May 19, 2017
ADDENDUM #2

Re: INVITATION FOR BIDS: **17-037-CW New Senior Citizen Community Center**

Information for Addendum No. 2

1 / A201 REFLECTED CEILING PLAN
1/8" = 1'-0"

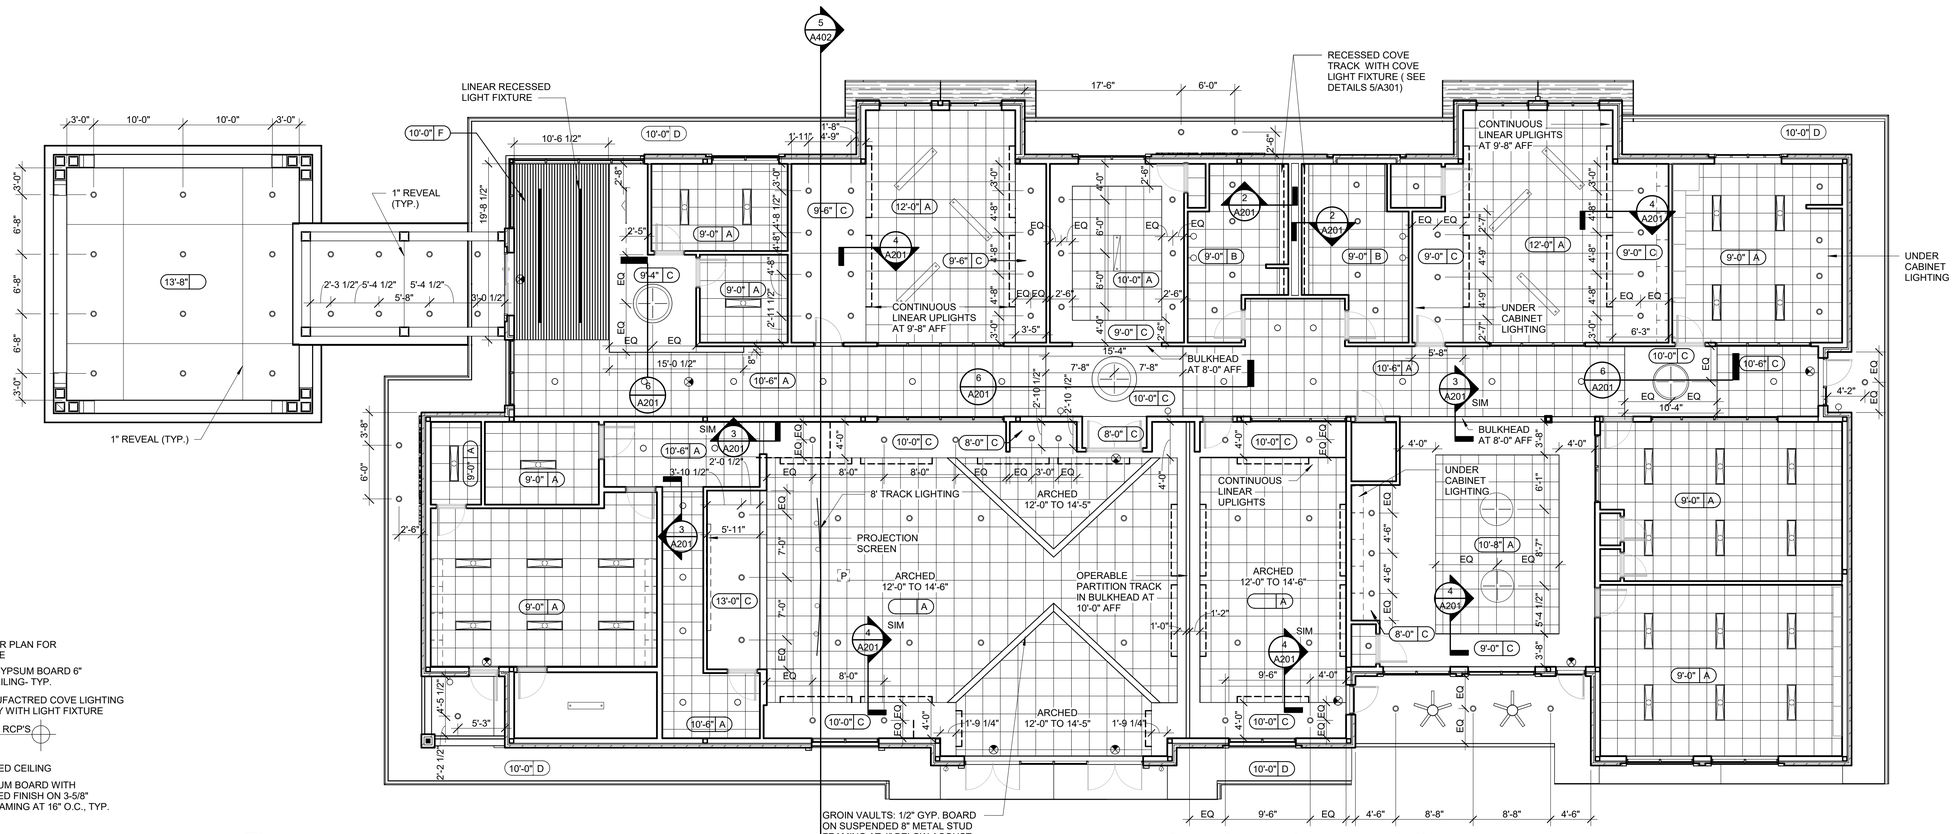
2. The attached Revision 1 to the Reflected Ceiling Plan sheet A201 replaces sheet A201 in the bid documents and clarifies the locations for the linear lighting at the Exercise Room 105, Sewing Room 111, Multi-Purpose Room 125 and Card Playing Area 123.

1 A301 FINISH PLAN
1/8" = 1'-0"

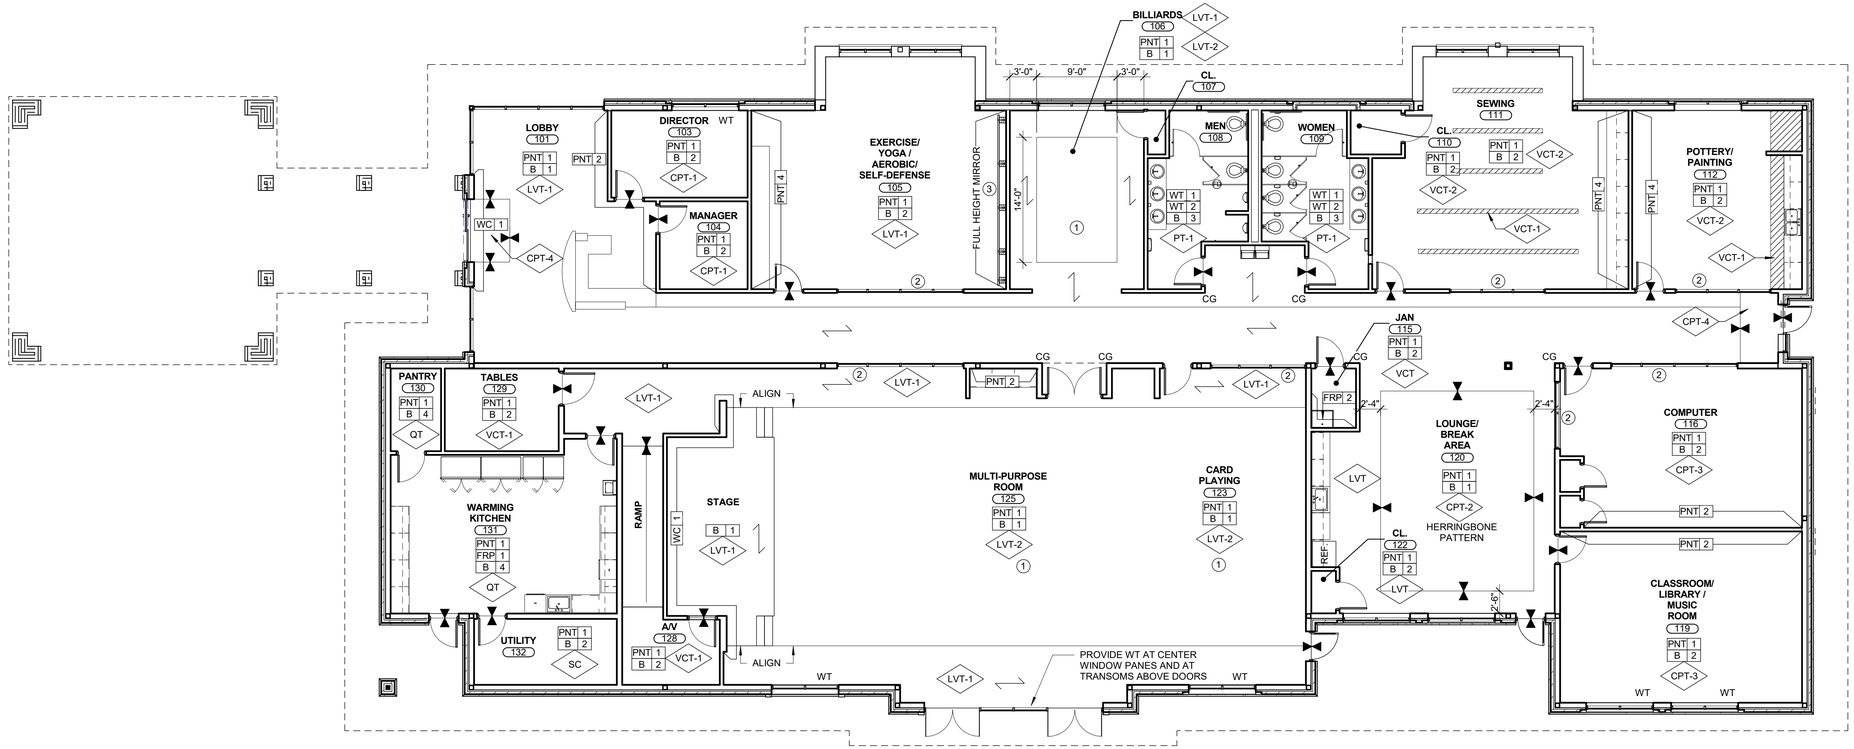
3. The attached Revision 1 to the Finish Plan sheet A301 replaces sheet A301 in the bid documents and provides locations for the corner guards and window treatments. Corner guards are to be as specified in section 10 2600 of the Specifications Manual. Window treatment are to be MechoShades model Mecho/5 Roller Shade system by MechoSystems or equal with manual operation.

2 WINDOW SCHEDULE
A801 — 1/4" = 1'-0"

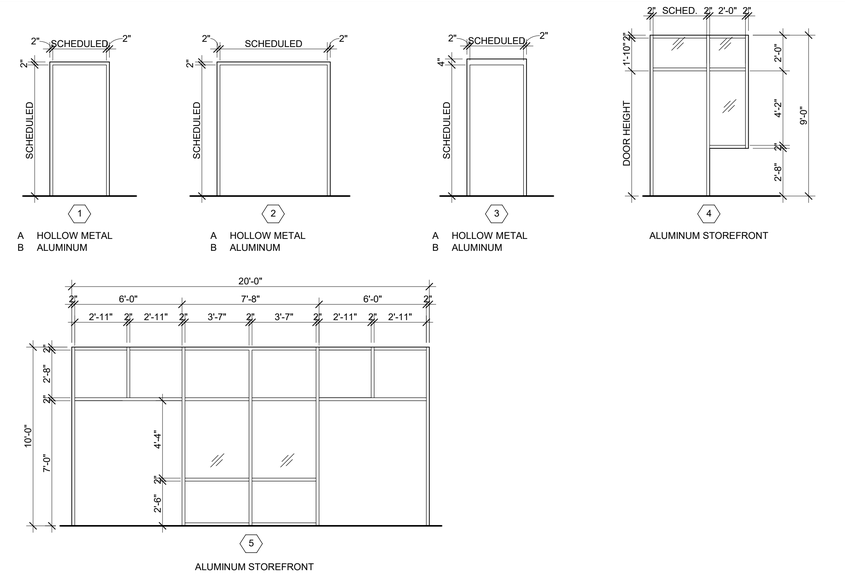
4. The attached Revision 1 to the Door and Window Schedules sheet A801 replaces sheet A801 in the bid documents and revises window types H3, H5, H6 and H7 to be single pane

2 CIRCUITING FOR TERMINAL UNITS (TU) AND FAN POWERED BOXES (FP)

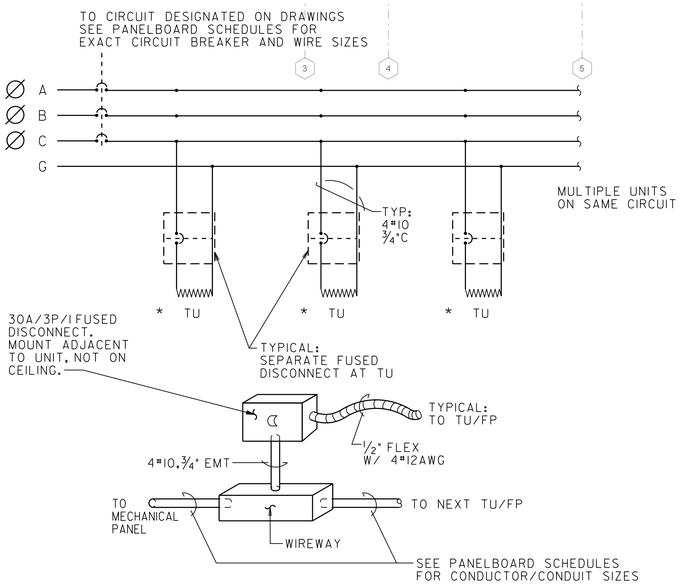
10. Q: Panel schedule for “MDP” on sheet E801 shows circuit #25 feeding TU units on a 100 amp breaker with #10 wire.

3 GROUNDING RISER

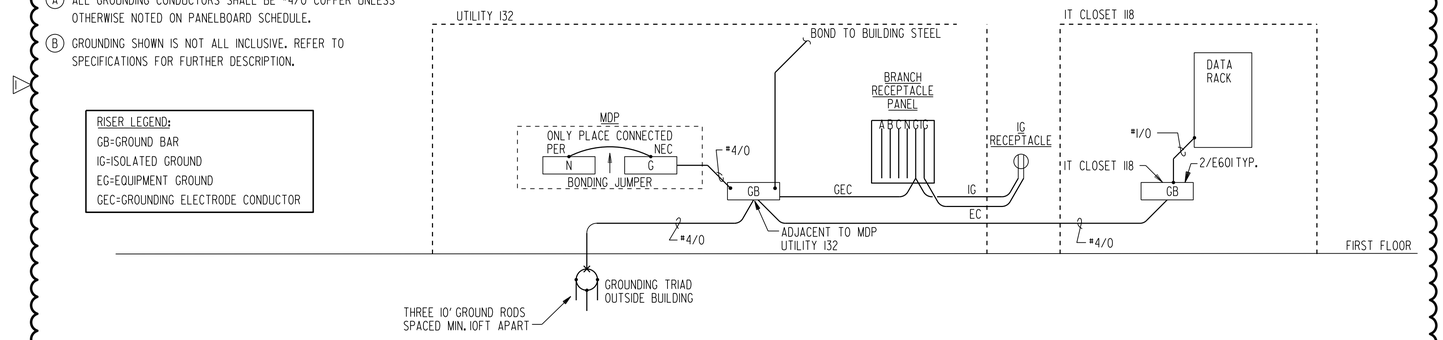
8. Q: There is no grounding detail for the service. We can install according to code, but you all usually have one shown.

A: Provide a grounding triad with #4/0 AWG connected to the ground bar in Utility 132. Connect the ground bar in the IT closet 118 to the ground bar in utility 132 with #4/0 AWG.
